Conceptual Review Agenda

CONCEPTUAL REVIEW: APPLICATION

Re: 718 S College - Mixed Use

Re: Brookfield Replat

718 S College Mixed Use

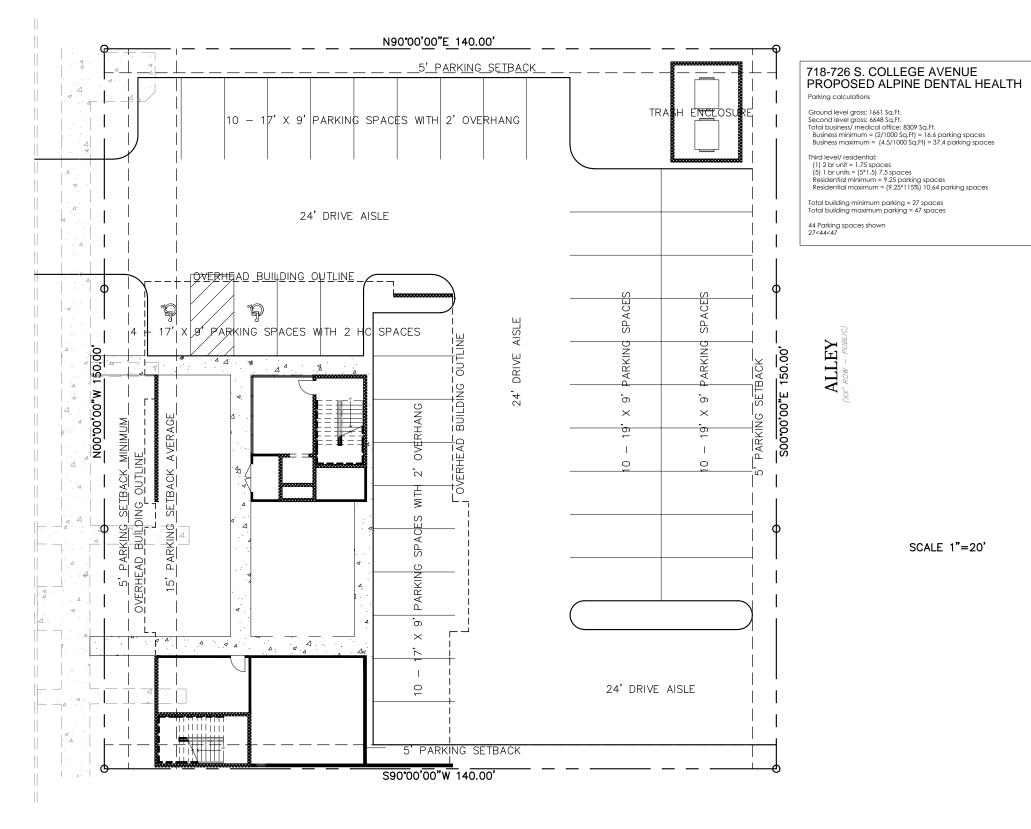
- **8.** LCUASS parking setbacks (Figure 19-6) apply and will need to be followed depending on parking design. The parking off of College Ave doesn't look like as designed is meeting this standard.

- **1.** The parking lot does not show any landscaping. You will be required to landscape 6% of the interior space per Land Use Code section 3.2.1(E)(5). This can be provided through landscape islands and should be provided so that they do not impact driver visibility.

- **4.** All rooftop mechanical equipment shall be screened from public view per the standards in Land Use Code section 3.5.1(I).
- 5. Staff is concerned with the streetscape and pedestrian experience given the current site plan and layout. The curb cut coming off College interrupts the pedestrian experience and provides a point of conflict for pedestrians and cars. The building overhang with the main entrances setback does not provide for the quality pedestrian environment envisioned in the TOD. Staff would like to discuss ways to improve this building's interaction with the street to improve the pedestrian experience of the site.

Final Development Site Plan

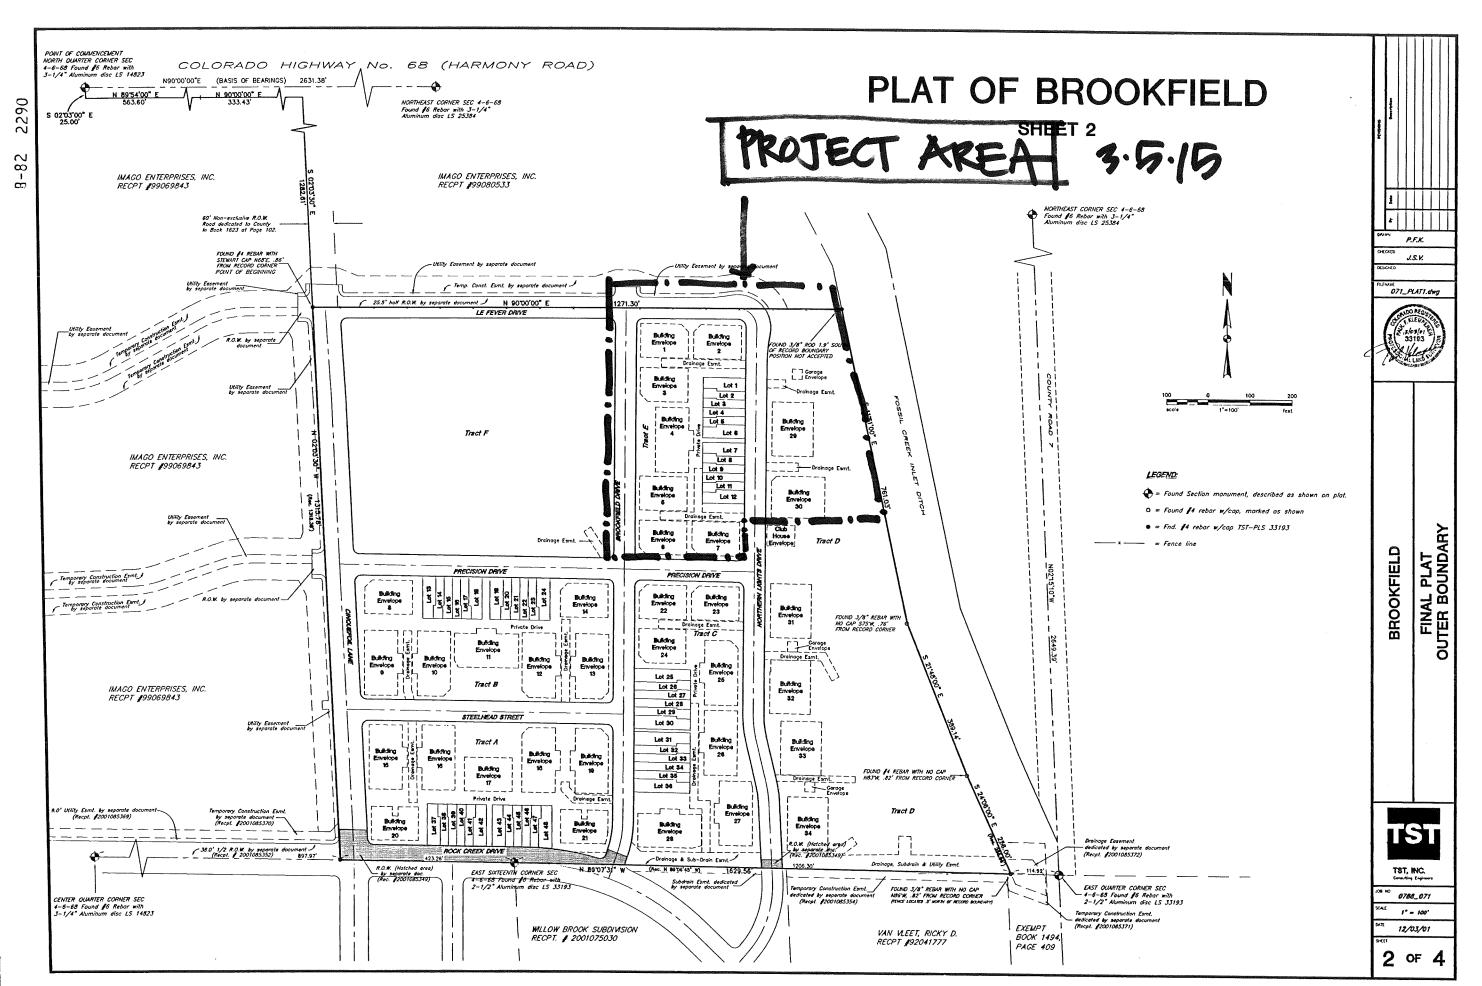
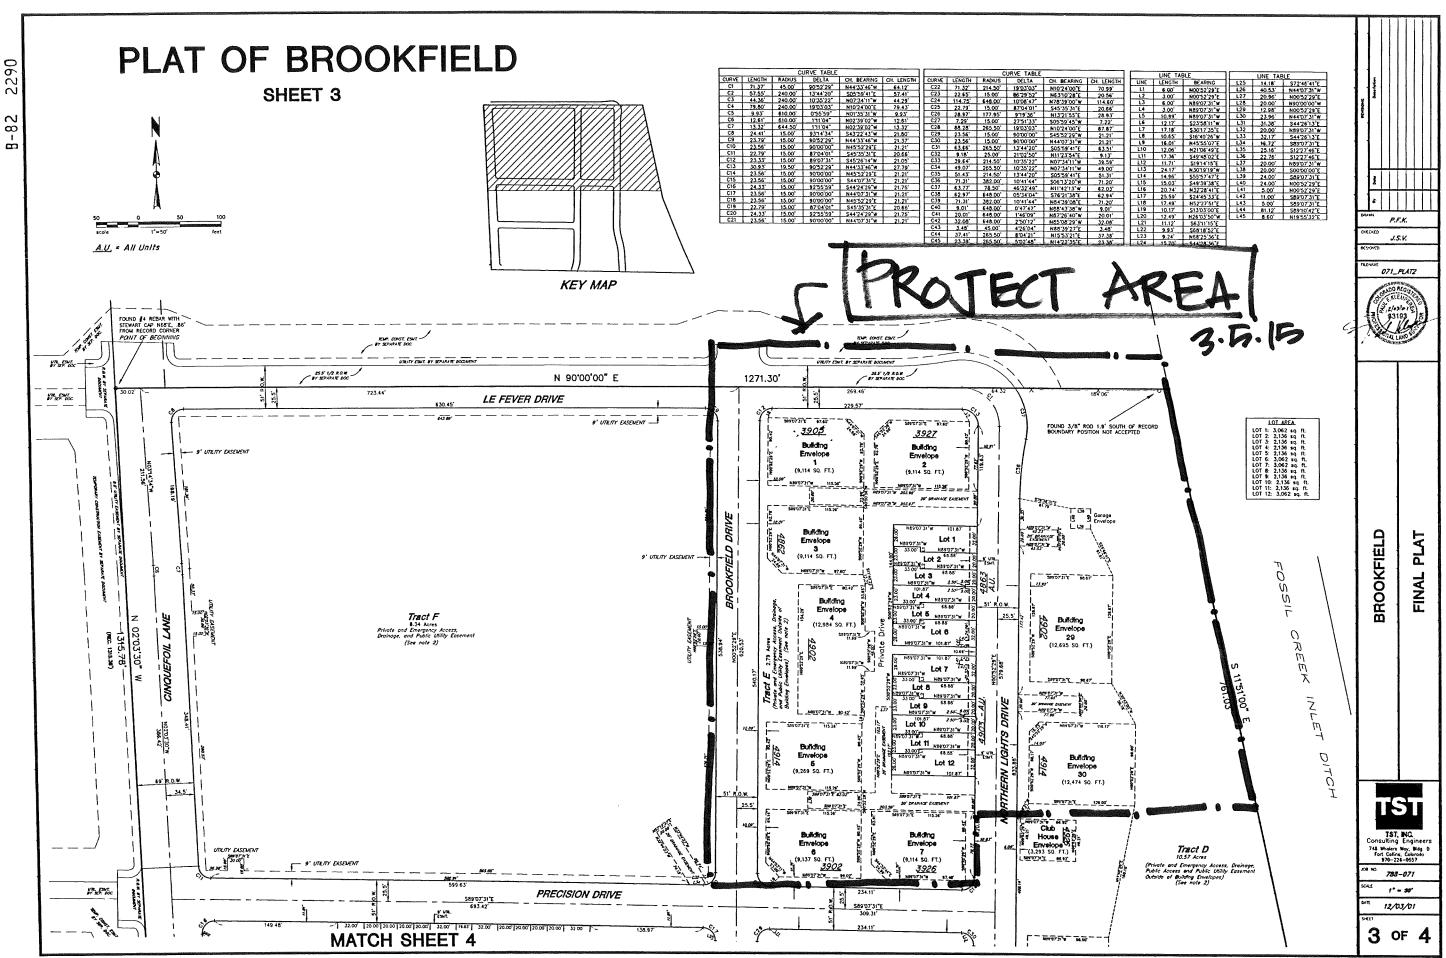
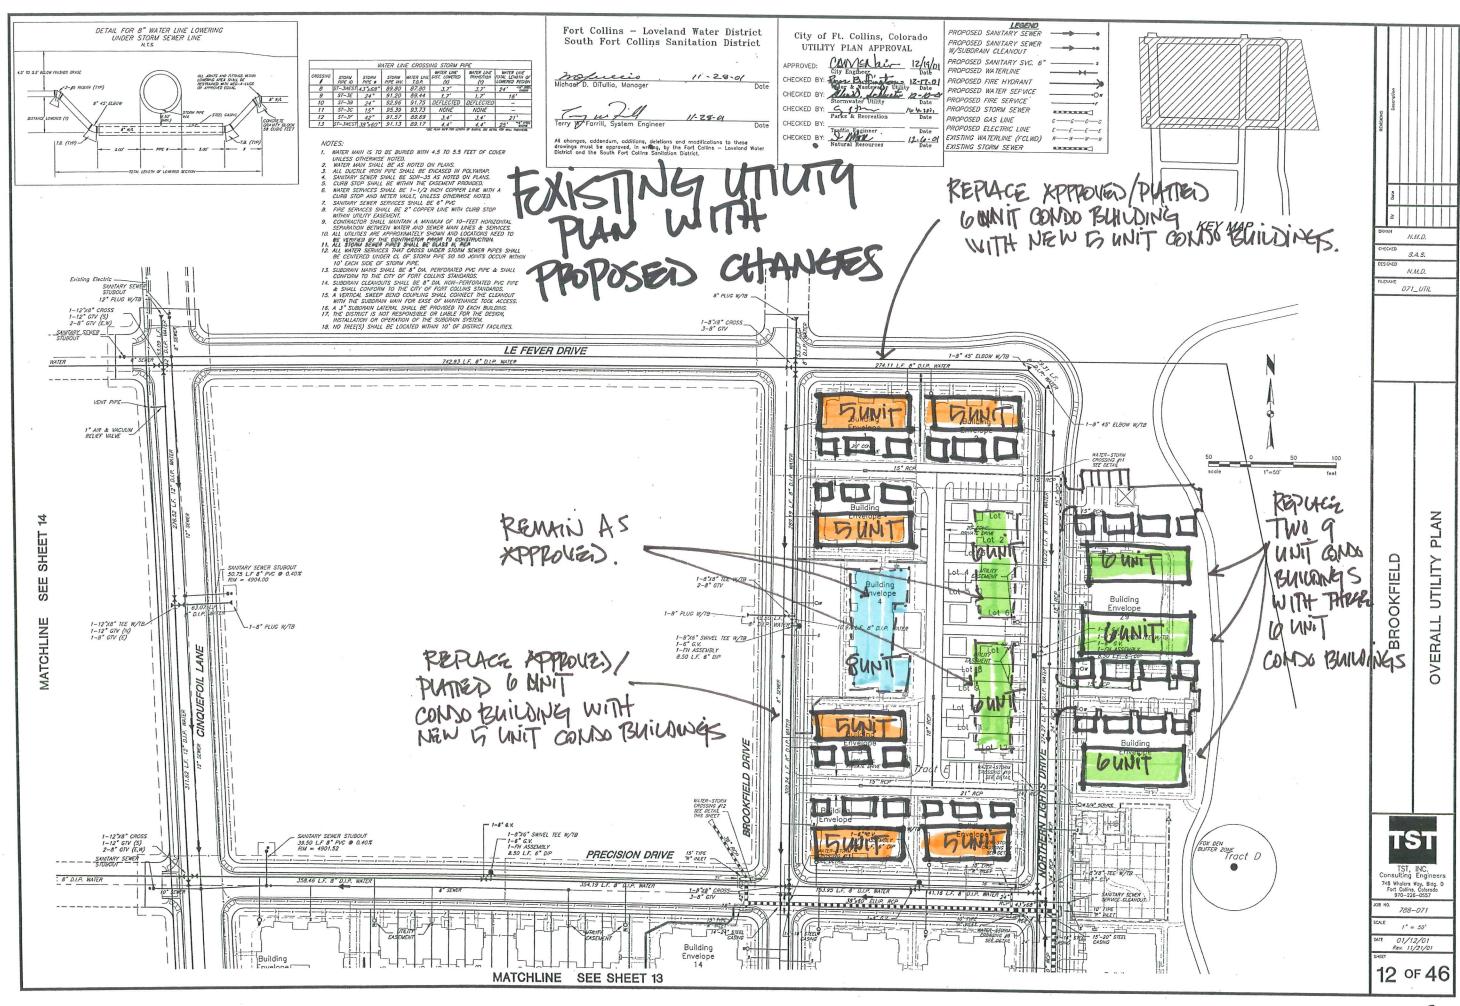
1. The elevations for the 5-plex and 6-plex must meet the City's building variation standards. These standards were updated in 2014 and are now applicable to both multi-family and single-family attached buildings. The standard is outlined in LUC 3.8.30(F) and 3.5.2(C)(2) and we would suggest being familiar with the details of code narrative.

The updated standards clarify that developments not only need at least three distinctly different building footprints, but that there shall also be no similar buildings placed next to each other along a street or street-like private drive. Building designs are now required to be further distinguished by including unique architectural elevations and unique entrance features, within a coordinated overall theme of roof forms, massing proportions and other characteristics.

The implication of this standard is that the two 5-plex and two 6-plex buildings would need to have variation where they are adjacent to one another along La-Fever and along Northern Lights. To achieve noticably different variation we would suggest making one of each building with brick, and one of each with stone, and in addition, adding distinctive details to the building entrances so that the change in material is not the only distinctive feature. The reason for the "no similar adjacent buildings" requirement is to ensure that the overall master-planned building variation (at least 3 building footprints) that is seen in plan view is also noticable in the street view.

- 2. Please be aware that there may be issues with emergency access for the 6-plex buildings to the east. If the garage alleys are needed for access, typically the limit for dead-end drive aisles is 150 feet.
